# UNITED STATES PATENT AND TRADEMARK OFFICE

APPLICATION NO.	FILING DATE	FIRST NAMED INVENTOR	ATTORNEY DOCKET NO.	CONFIRMATION NO.
10/581,325	06/01/2006	Dieter Hagist	502901-348PUS	3578
27799 7590 09/24/2009 COHEN, PONTANI, LIEBERMAN & PAVANE LLP 551 FIFTH AVENUE SUITE 1210 NEW YORK, NY 10176				
EXAMINER BAYOU, AMENE SETEGNE				
ART UNIT 3746		PAPER NUMBER		
MAIL DATE 09/24/2009		DELIVERY MODE PAPER

### Office Action Summary

## **DETAILED ACTION**

#### **In Reference to Claim 1**

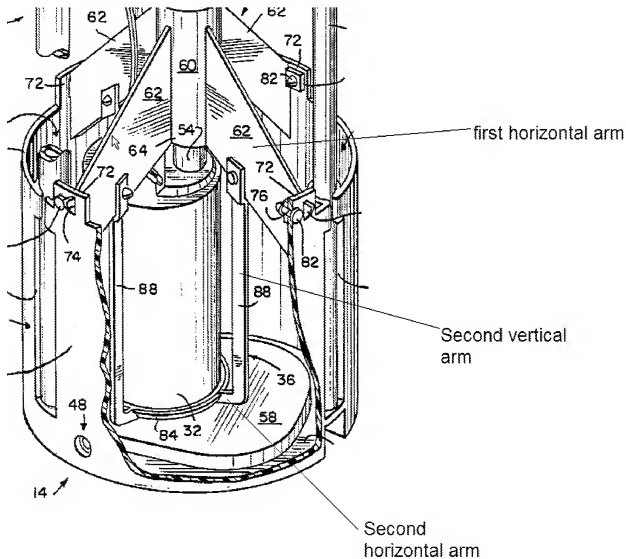
Harris teaches a device for retaining a fuel pump in a fuel container of a motor vehicle (see figure 1), with a pump holder (including fin members (62) and legs (88)), with first retaining means of the pump holder (the fins (62)), provided for supporting on a baffle pot (the fins are supported on a reservoir cup (30)), and with second retaining means of the pump holder (pump carrier dish(84)), provided for supporting the fuel pump, and with a damping device (the legs (88)) connecting the first and the second retaining means to one another, in that the damping device has arms which are angled away from each other (the legs (88) have a vertical portion and a horizontal portion that is arranged at 90° to the vertical portion. In addition item 62 which is attached to the

horizontal portion of vertical legs 88 can be considered as a horizontal arm), and in that during a movement of the fuel pump the arms are subject to at least a torsional or a bending load (the arms would be subject to any stresses applied to the fuel pump and fuel tank, which includes bending and torsional loads), wherein the arms of the damping device include at least one first vertical arm extending substantially in a vertical direction and first and second horizontal arms extending substantially horizontally and angled away from the first vertical arm (the legs (88) have a vertical portion and a horizontal portion that is arranged at 90° to the vertical portion), the first and second horizontal arms being spaced apart in the vertical direction, and at least one of the first and the second horizontal arms is designed as an annular element (the vertical arms are arranged annularly around the fuel pump), wherein a second vertical arm (one of the vertical arms 88 can be considered second vertical arm) connects the first horizontal arm and the second horizontal arm of the damping device (see annotated drawing), and wherein only the second horizontal arm of the arms of the damping device is directly connected to the second retaining means (see annotated drawing again).

13. Applicant's arguments with respect to the rejection of claims 1-20 over Frank have been considered and found persuasive. Therefore the rejection is withdrawn. However applicant's argument with respect to the rejection of claim 1-20 over Harris (see page 4 paragraphs 2 and 3) is not found persuasive. Applicant argued that the legs 88 of Harris are disposed in the same horizontal plane and are not spaced apart in the vertical direction. Examiner notes that there is some confusion by the applicant in labeling the vertical legs and the horizontal portion of the legs (i.e. the arms) as being the same (see annotated drawing above for clarification). As clearly be seen in the drawing the

horizontal arms of the vertical legs 88 are spaced apart in vertical direction and are not located on the same horizontal plane.
